ASK 21 B Technical Note

No. 5

Subject: Inspection of the screw lock at the automatic connection of the airbrake control system

Applicability: ASK 21 B; Type Certificate EASA.A.221; serial numbers 21953 – 21982 (S/N 21955 not

Fig. 1: Stop at the left automatic connection of the airbrake control system

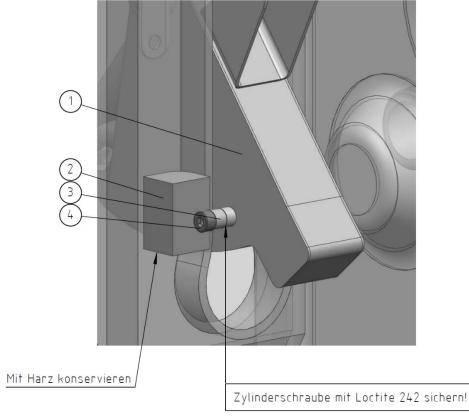
Reason: A socket head screw M5x10 was found in one case in the fuselage of an ASK 21 B during

pre-flight inspection. Investigations have shown that this screw was initially mounted at the automatic connection of the airbrake control system at the left wing-to-fuselage junction. Loosening of this screw was caused by a missing screw lock. It cannot be excluded that

Action: Inspection of the stop at the automatic connection of the airbrake control system at the left

The cone (pos. 1) of the automatic connection of the airbrake control system at the left wing-to-fuselage junction is equipped with a stop which prevents overcentre locking when the aircraft is de-rigged. The stop is realised by a DIN912-M5x10 socket head screw (pos. 4) which is screwed into the lateral wall of the cone by the use of an additional brass-bushing (pos. 3). The counterpart is a plywood block (pos. 2) which is glued on the inner side of the fuselage root rib. It must be checked that the screw and the brass bushing are in place. If both parts are present, unscrew the screw and insert it again secured with Loctite 242. If the screw and bushing are missing than the complete fuselage must be checked for these parts. Only when it is ensured that these parts are not in the fuselage than the stop can be reinstalled using a new screw and bushing. Secure the screw using Loctite 242.

The plywood block at the root rib must be protected against moisture using epoxy resin coating.
